## UNITED STATES PATENT AND TRADEMARK OFFICE

<b>Office Action Summary</b>	<b>Application No.</b> 10/748,059	<b>Applicant(s)</b> TENHUISEN ET AL.
	<b>Examiner</b> DIANNE DORNBUSCH	<b>Art Unit</b> 3773

## DETAILED ACTION

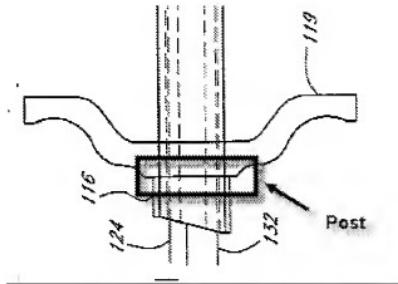
Claim 9: Mikus discloses all the claimed limitations discussed above (see rejection of claims 1-4 and 6-8) including that said grip portion (119) has a hollow post (see figure below) extending from said hub (Fig. 13), said post having a relief slot (the distal opening of the post) on a distal end thereof (see figure below), said relief slot positioned on said post to align with said tab when said tab is in the deployed position (Fig. 13-14), said tab capturing the at least one protrusion of the stent between said tab and said relief slot when said apparatus compresses the at least one protrusion (Fig. 13). Note that the relief slot of claim 1 is on said hub and not and said post. The post is not claimed in claim 1 therefore a different release slot in the same reference was used.
